# **An introduction of Three-Dimensional Precipitation Particles Imager (3D-PPI)**

## **Response to the reviewers**

Jiayi Shi, Xichuan Liu, Lei Liu, Liying Liu, Peng Wang

[Figure C.1. Top view of wind speed distribution in the simulated wind field. 3D-PPI facing 10 m/s wind \(a\); back facing 10 m/s wind \(b\); side facing 10 m/s wind \(c\). The color gradient represents wind speed, with the observation volume indicated in \(a\).](#)

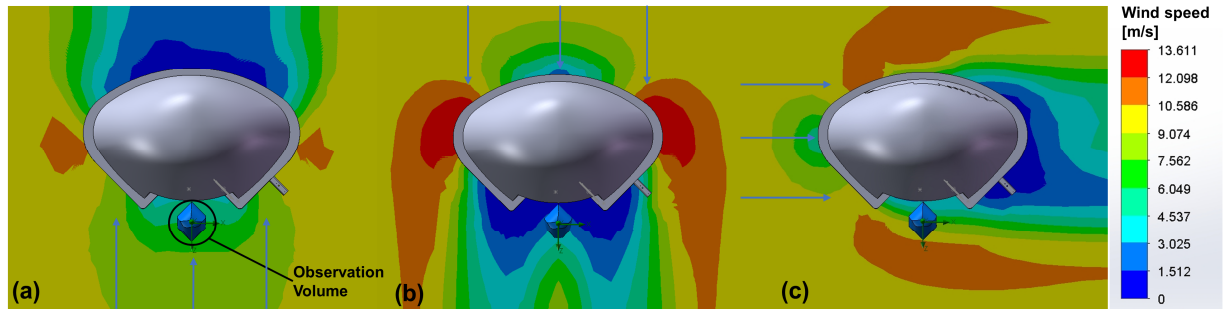
*2. Given that the sampling volume is so close to the instrument housing, how will wind flow affect the representativeness of the measurements (e.g., increasing or decreasing the collection efficiency of the sampling volume)? While I understand that a full engineering analysis of the wind effects (similar to what was presented in Fig 3 of Newman et al. 2009, <https://doi.org/10.1175/2008JTECHA1148.1>) may be outside the scope of this paper, some analysis that compares the 3D-PPI to the PARSEVAL with the wind coming from certain directions relative to the camera pointing direction might help give some insight into how well the instrument handles these conditions.*

Thanks for your comments. We have added the wind field simulation in the Appendix C.

To determine the optimal orientation of the 3D-PPI installation (mainly considering the relationship with the prevailing wind direction), we conducted wind field simulations using Solid flow simulation software. The simulation results are shown in Fig. B.1.

When the 3D-PPI is facing the wind (Fig.B.1a), the observation volume experiences an average wind speed of approximately 6.0 m/s. Besides, turbulence may occur within the observation volume. When the 3D-PPI is back facing the wind (Fig. C.1b), the average wind speed in the observation volume is only about 3.5 m/s, which is obviously due to the shielding of the wind by the instrument. When the 3D-PPI is side facing the wind (Fig. B.1c), the observation volume shows an average wind speed of about 8.5 m/s, exhibiting the smallest difference from 10m/s, compared to the other two situations. However, part of the observation volume close to the instrument is still shielded by the housing, which to some extent also affects the representativeness of the wind field, and subsequent consideration will need to be given to improving the instrument design to solve this problem.

In addition to 10m/s, we also simulated 5m/s, 20m/s, and 40m/s wind speed fields, and all of them got the consistent conclusion that the wind speed in the observation volume is closest to the simulated wind speed when the instrument is side facing the prevailing wind direction. Therefore, the instrument should be installed sideways to the dominant wind direction in the area, to minimize the disturbance of the instrument to the natural wind field. The prevailing wind direction in the area is west, so the 3D-PPI is installed facing towards the south.

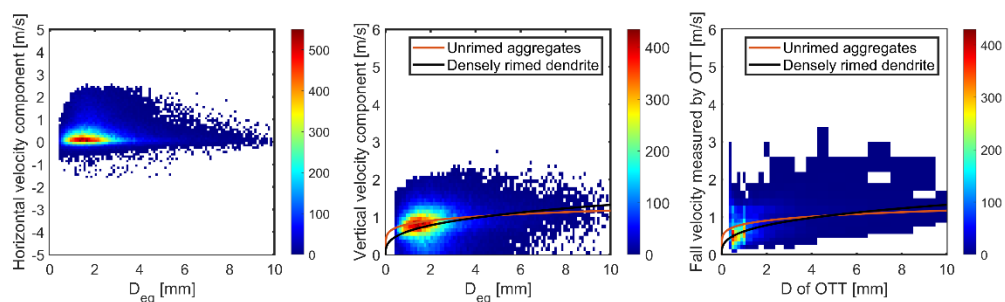
13.Lines 390 – 391: *Is the 200 pixels interval purely in the vertical or is that include the horizontal component of the distance as well. If that includes the horizontal distance, it might be worth noting that this means the instrument will have difficulty producing accurate particle fall speeds at high cross-camera-view wind speeds (which isn't a problem, but is good to know for anyone performing an analysis of the data).*

Thank you for your comments. The 200 pixels interval represents a purely vertical speed measurement. The horizontal velocity of snowflakes is heavily influenced by wind speed, which can exceed 10 m/s, while the vertical velocity typically does not exceed 4 m/s. We appreciate your reminder regarding the 8 m/s speed; indeed, it is somewhat higher. We have reformulated that statement to reflect that the maximum vertical speed is 4 m/s:

(ii) the pixel coordinates in the particle images are similar (the falling velocity of the snowflake is generally not more than ~~48~~4 m/s, so the interval between neighboring snowflakes is not more than ~~100200~~100 pixels);

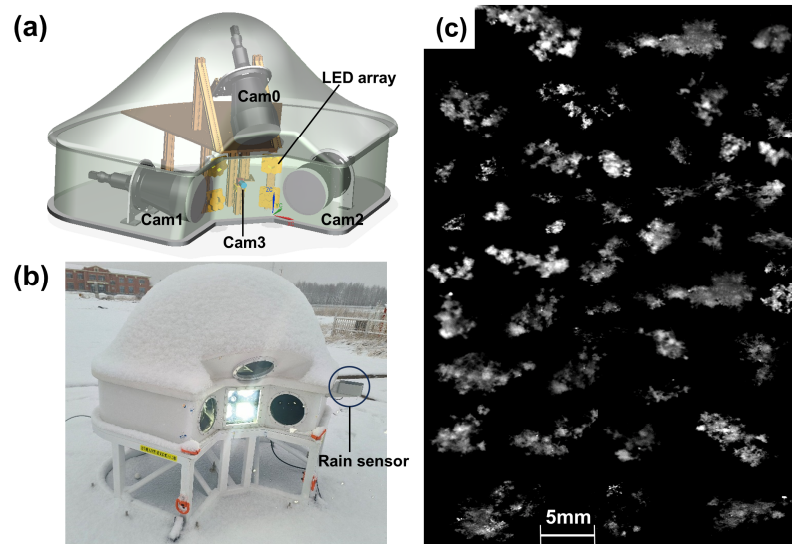
*3) 86-87, “capacitive rain sensor is adopted as a trigger, the cameras only work when the precipitation occurs.” Rain sensors detect rain. When you say the cameras only work when precipitation occurs, do you mean when it rains? I would expect you want to measure with snow but perhaps not with rain? Please clarify.*

Thank you for your comments. To clarify the point in Lines 86-87, we would like to emphasize that the capacitive rain sensor is designed to trigger the operation of the 3D-PPI instrument whenever precipitation occurs, regardless of whether it is rain or snow. The sensor detects any moisture on the instrument's surface, and its heating element ensures that snow is melted and then sensed. We have added the following description in the revised manuscript (88-90).

To improve the instrument's working efficiency, a capacitive rain sensor is adopted as a trigger, the cameras only work when the precipitation occurs. [The sensor detects any moisture on the instrument's surface, and its heating element ensures that snow](#)
